ADDENDUM

ADDENDUM NO: 03

PROJECT: Center Grove HS Renovations – Package 2

DATE: September 4, 2026

1 POWER AND SYSTEM - MANUFACTURING LAB - NEW WORK

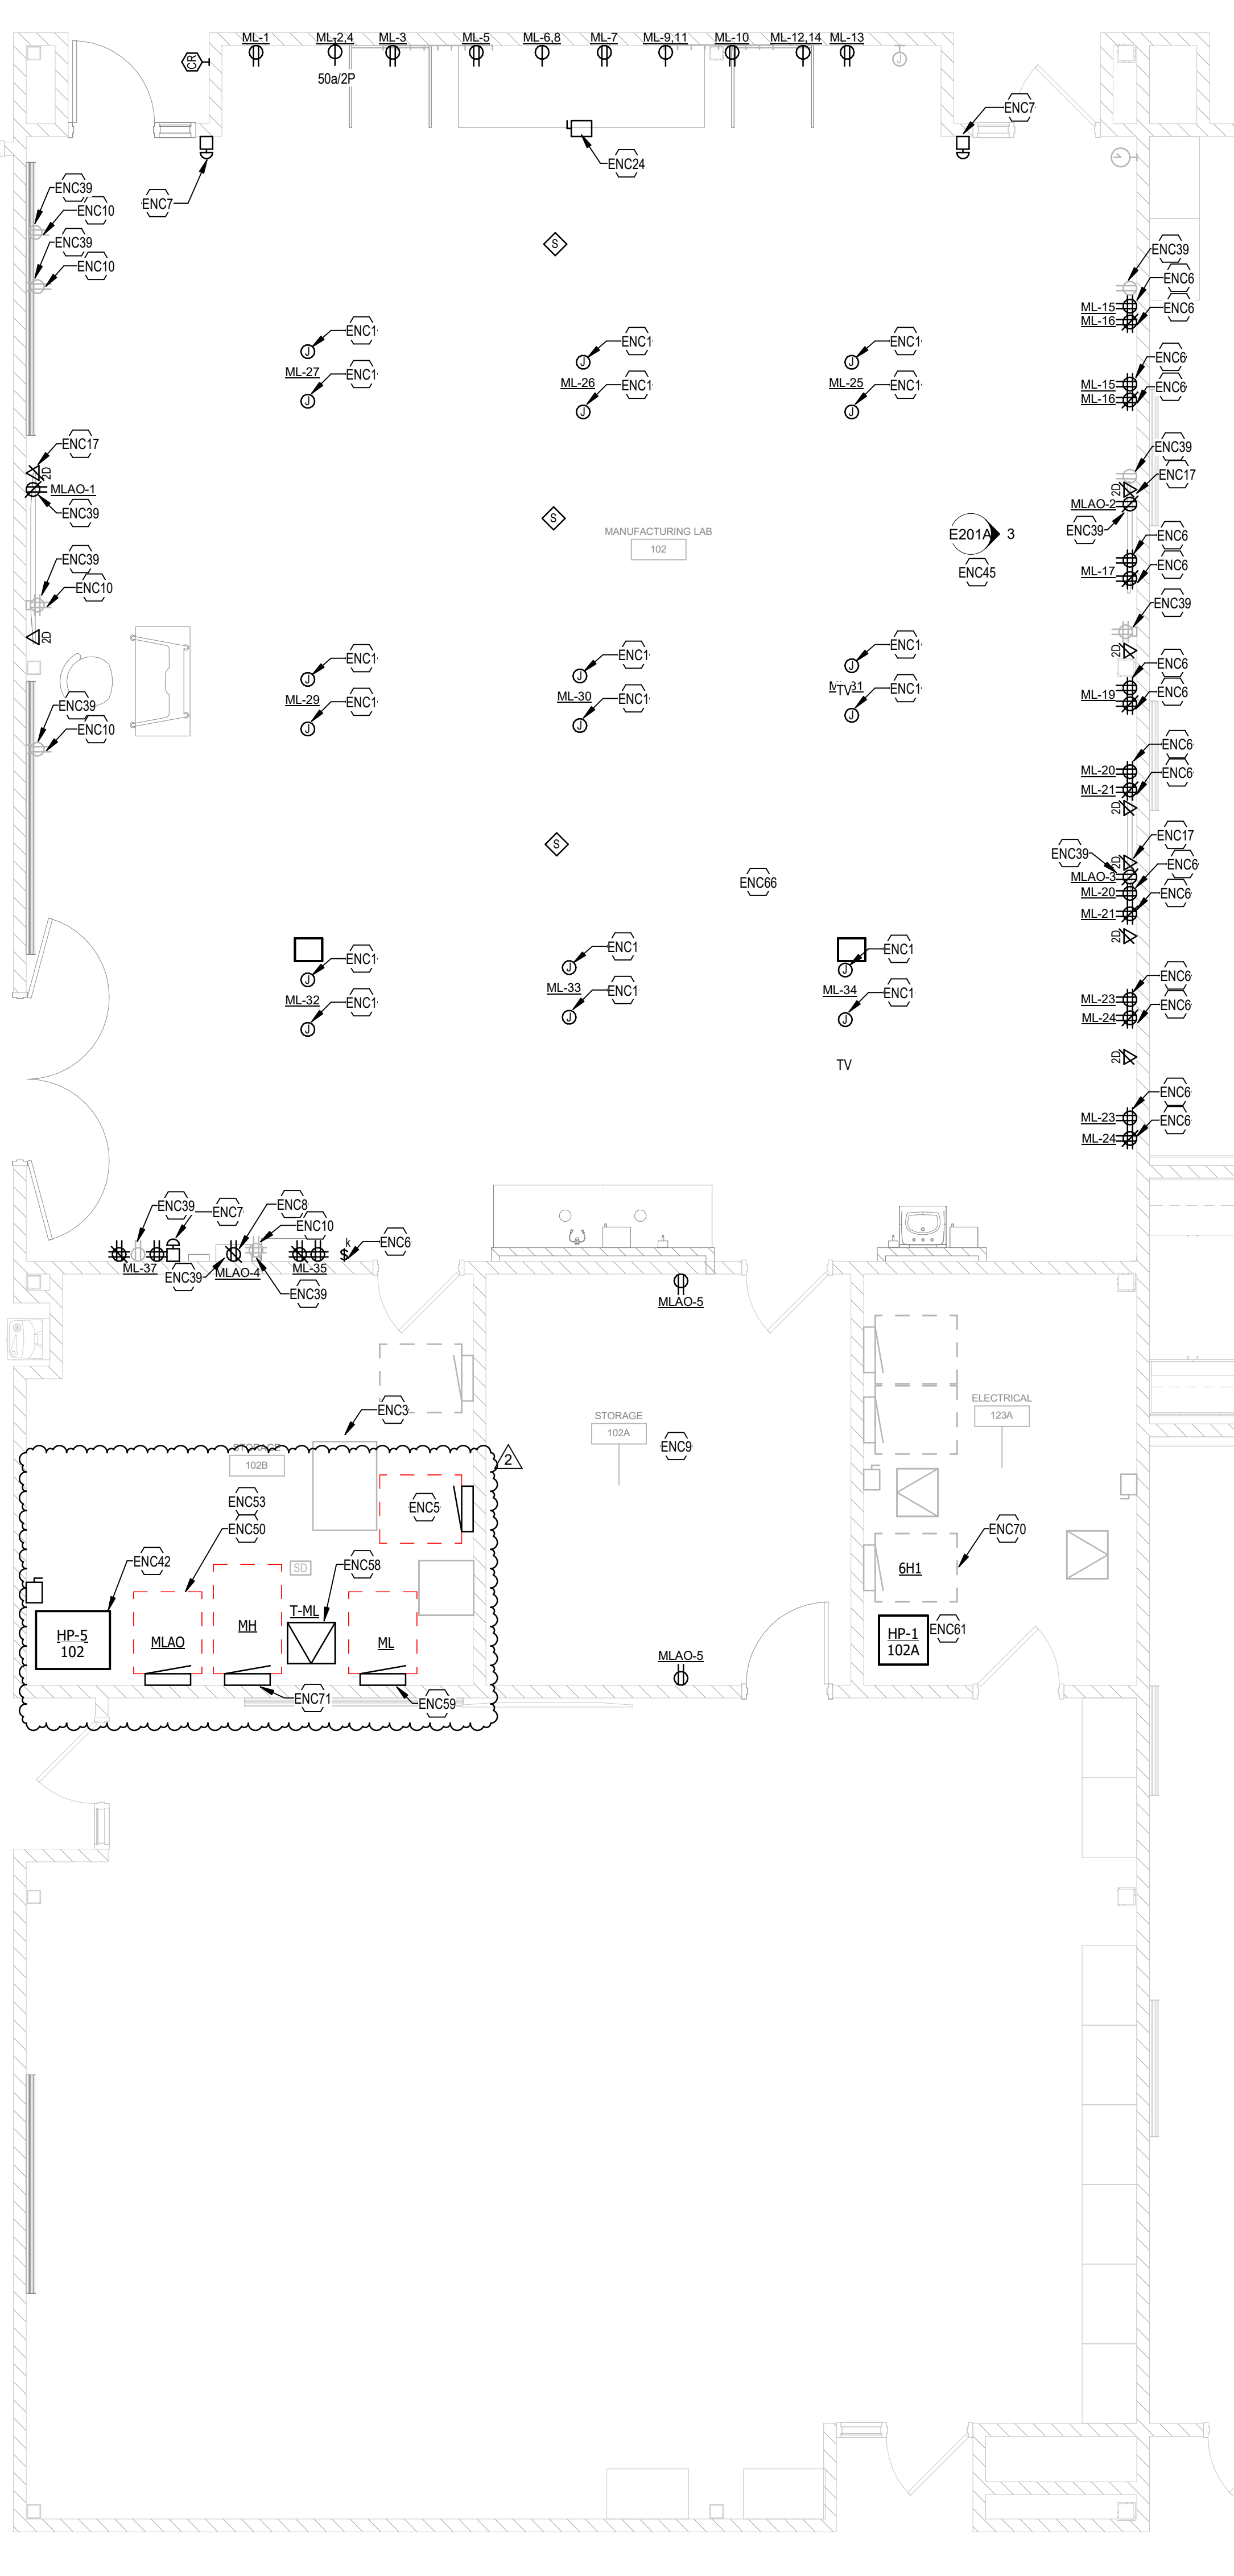
3.11 E201.2 - LOWER LEVEL ELECTRICAL NEW WORK PLANS - UNIT A - ALTERNATE 2

- A. Refer to "E201A – LOWER LEVEL ELECTRICAL NEW WORK PLANS – UNIT A" in narrative for changes.

1 POWER AND SYSTEM - MANUFACTURING LAB - NEW WORK

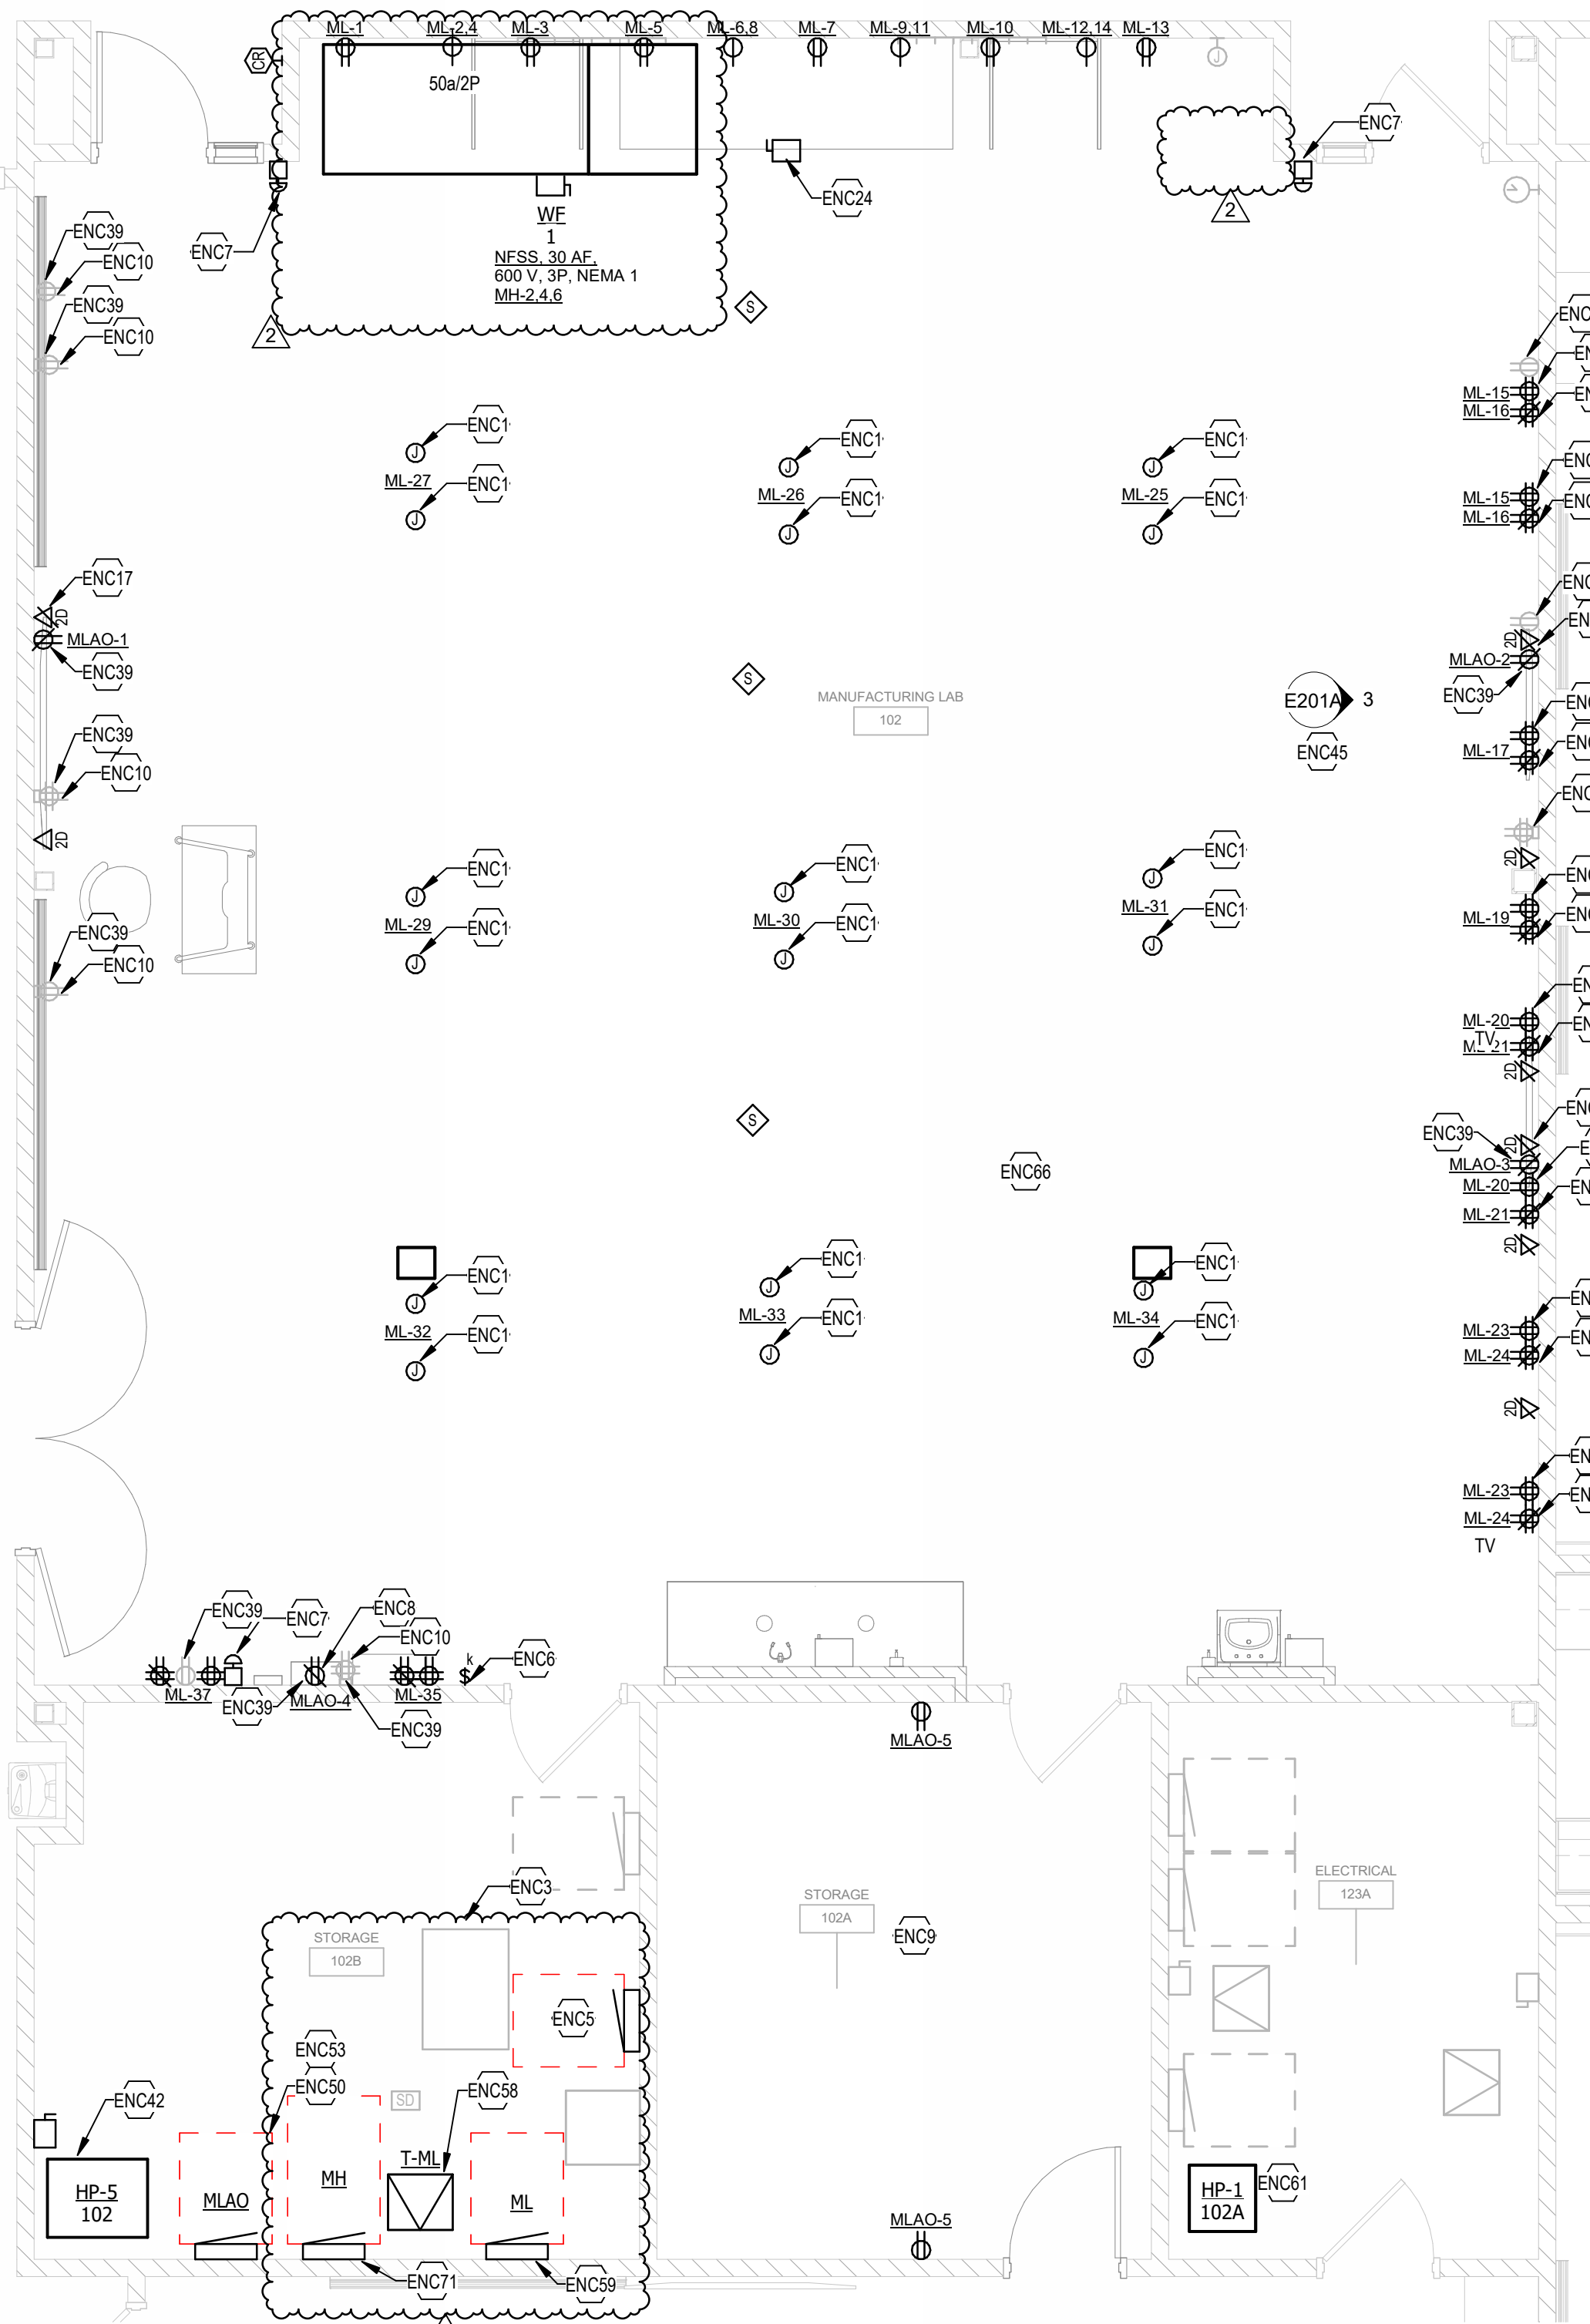
- A. Removed two motorized switches previously serving (2) WF-1.
- B. Added one (1) non fused disconnect for new WF-1.
- C. Added one (1) 480/277V MH panel.
- D. Added tagged note ENC71.
- E. Replaced 75KVA transformer with 45KVA transformer, Updated tagged note ENC58.
- F. Updated wire size between T-ML (transformer) and ML (panel). Tagged note ENC59 updated (wire size from 3-4/0 to 3-1/0 and ground size from #2 to #6).
- G. Added CONSTRUCTION LAB 127 – EXISTING RELAY PANEL AND KEYED SWITCH view.

- A. Sheet E201A Tagged note ENC5 mentions to provide relay panel and refer to adjacent lab and match equipment/ components. Can you provide Details/ specifications, and photos of the existing lab control panel.
